**CABINET MEMBER FOR HIGHWAY MANAGEMENT –
17 NOVEMBER 2022**

**WALLINGFORD - READING ROAD: PROPOSED BUS STOP
CLEARWAYS**

Report by Corporate Director, Environment and Place

ANNEX 2

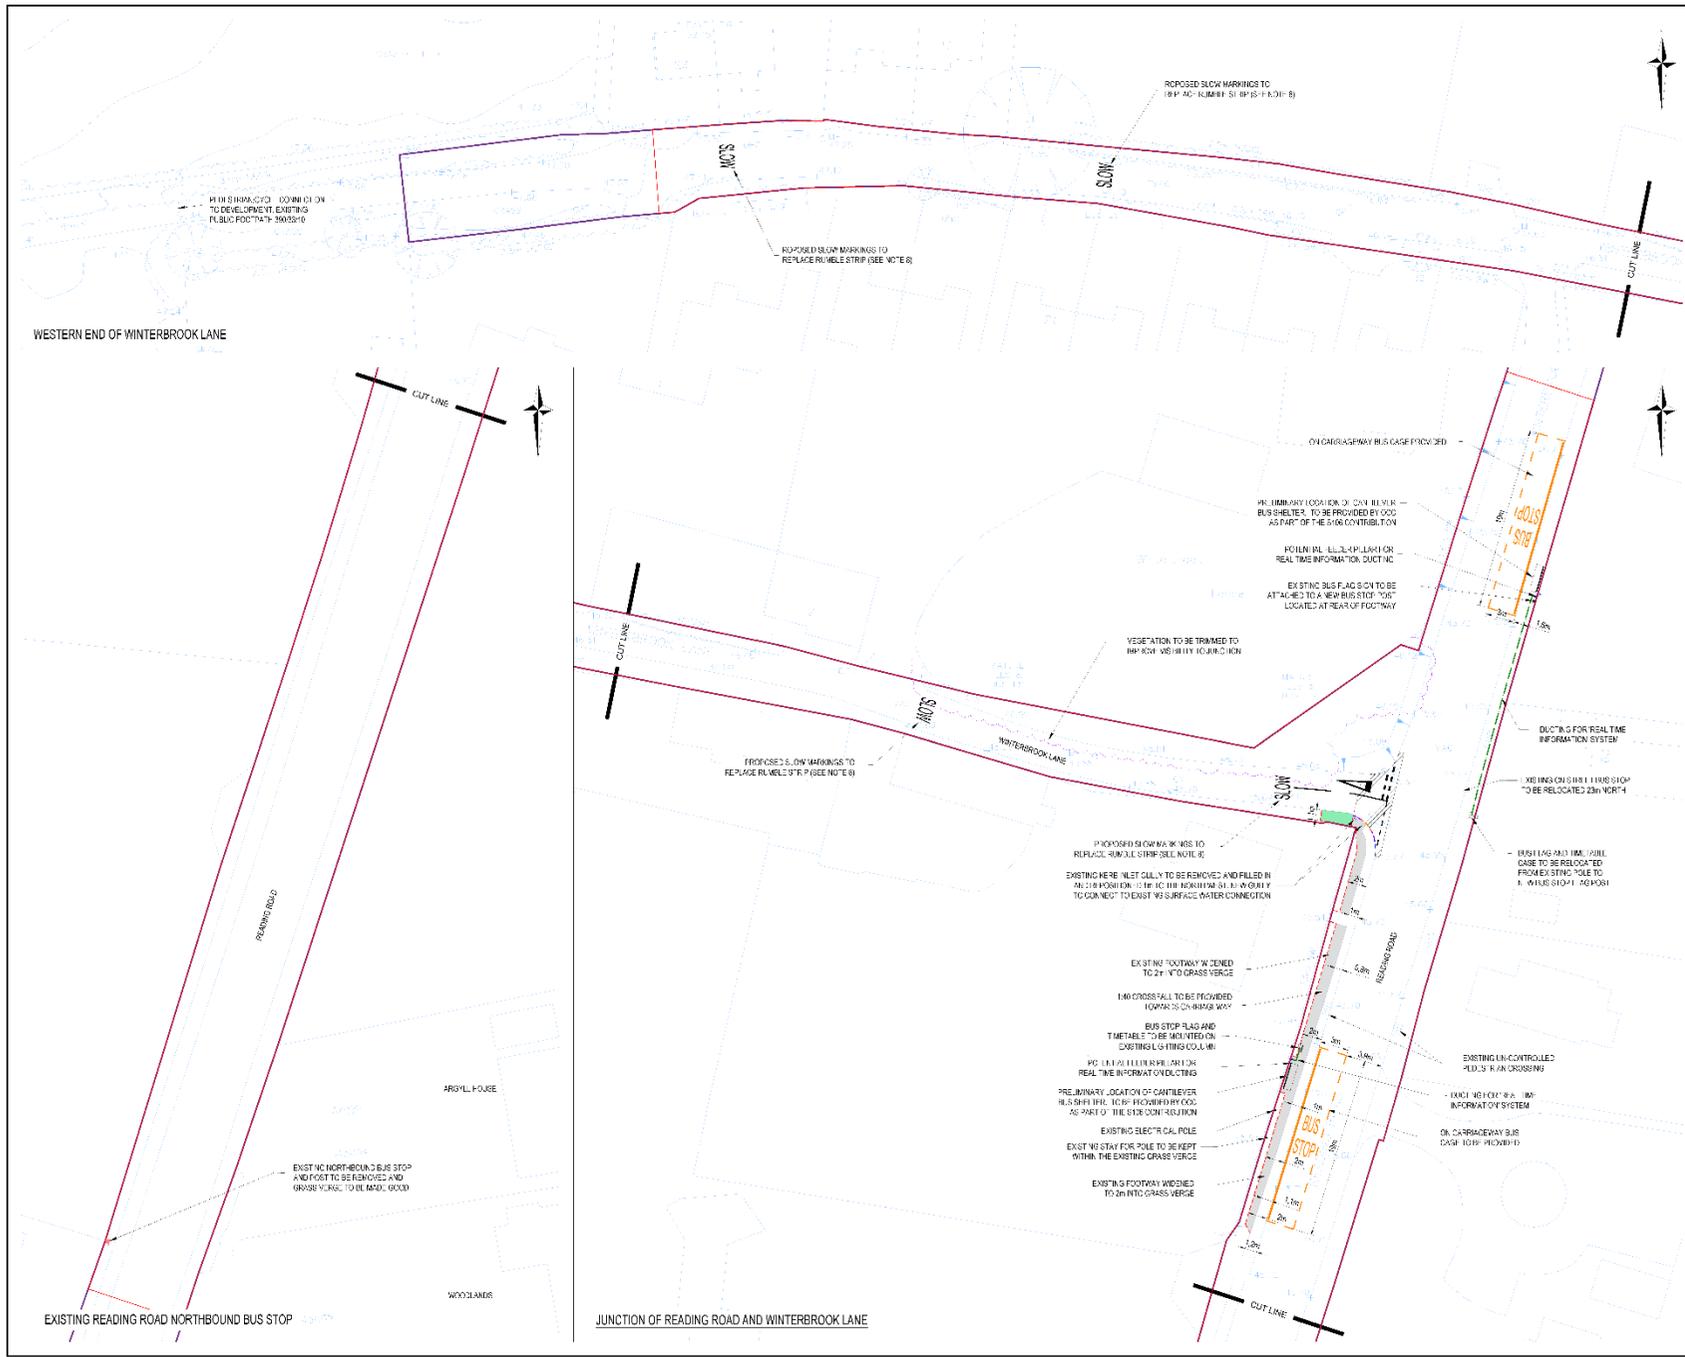
The drawing sent to us does not reflect the properties as they stand at present which is a crucial flaw that requires correction. You are showing the old cottage not our new dwelling and you do not show our new exit nor the new exit onto the road at our next door neighbours property. Neither does it show the revised entrance at number 33. All of these properties have frequent visitors daily all of whom exit close to these proposed new bus stops.

I would also question whether the road near to the proposed bus stop outside the former home of Agatha Christie is wide enough to accommodate a bus shelter and a footpath.

<p>In summary your proposals are seriously detrimental to the safety and to the mental health of the owners of those properties in the immediate vicinity. They are likely to significantly reduce our amenity through increased noise and pollution. This would be from the vehicles held up by the buses remaining at these stops and by traffic from Winterbrook Lane and our own houses having engines running yet remaining stationary for longer time frames.</p>
<p>(4) Member of public, (Wallingford, Winterbrook)</p>	<p>Concerns – We have a number of concerns:</p> <ol style="list-style-type: none"> 1) In respect of the listing of our building and the designation of Winterbrook as a ‘conservation’ area which extends to our South boundary, we find the proposal to site a ‘cantilevered bus shelter’ directly adjacent to our boundary and within the conservation area to be quite contrary to the intentions of preserving the appearance of our listed building and maintaining the conservation area, however eroded the latter may have become by recent planning decisions. 2) The adjacency of both bus stops to the difficult and blind exit from Winterbrook Lane will increase the hazardous nature of the junction and the difficulty of negotiating traffic on the wrong side of the road from both directions (instead of one as at present) when buses are stopped. When buses are stopped on both sides of the road the traffic hazard adjacent to the junction will be considerably worsened. 3) The adjacency of both bus stops to the recently installed ‘tapered pavement edge’ to facilitate pedestrian /wheeled road crossing to the proposed bus stop represents a further hazard 4) There is an existing bus stop on the west side of the Reading less than 150 yards south, a second bus stop in such close proximity seems extraneous and unnecessary, it would be more sensible, if required, to site the ‘cantilevered bus shelter’ there or move the site to the adjacent junction of the Reading and Wallingford (old Cholsey turning). Either location is in a good position for the current buildings and residences at the south end of the Reading Road and would reduce the hazards described in points 2) and 3). 5) Winterbrook lane is a single vehicle track and in no way suitable for the central marked division of lanes as shown on the drawings. Neither are there currently ‘rumble strips’ as implied by the markings on the drawings.

4. At the proposed new site Northbound the plan states that the existing footway will be widened to 2m into the grass verge. That is welcome to give space for both waiting passengers under the new shelter and passing walkers to keep to the footway and avoid having to step into the street. At this point the plan marks the roadway as composed of a 3m wide bus clearway plus a 3.9 residual road width up to the opposite pavement. So the road here is 6.9m wide presumably.

5. But the proposed new stop Southbound is much narrower. The plan shows the footway as 1.6m. That will have to accommodate the new bus shelter, and all of the proposed clearway is against a substantial blank-faced brick wall. At this point the plan marks the Bus Clearway again as 3m wide, but it does not say how wide the road is opposite. In fact I believe that the remainder of the road is 2.7m, but that is my estimate. In fact both the roadway and the footway visually are clearly substantially narrower beyond no 29. So the road here I estimate to be 5.7m, and already very narrow for two buses to pass each other. The Clearway will be over the middle of the road here.

| | <p>A. Could there be provision to retain the existing northbound stop by the care home, or even further towards it. If so is there a possibility for a new stop opposite the care home Southbound and a piece of new local footway.</p> <p>B. Is the site of the new Southbound site overall too narrow, and is it likely that walkers and passengers will have to step into the road to pass each other, against an increasingly fast and busy road.</p> <p>C. Could the existing Southbound site be modified to continue.</p> <p>D. This roadway is no longer the A329, and its previous through traffic (eg Cholsey - Shillingford) could now use the bypass. Should this scheme include traffic calming to make the footways, frequent crossings, and bus stops much safer, and then by reducing average traffic speed naturally further reduce the 'Google' attraction of this short cut against the bypass. Should the whole road become 20mph.</p> <p>F. Should this proposal be given longer in consideration.</p> |
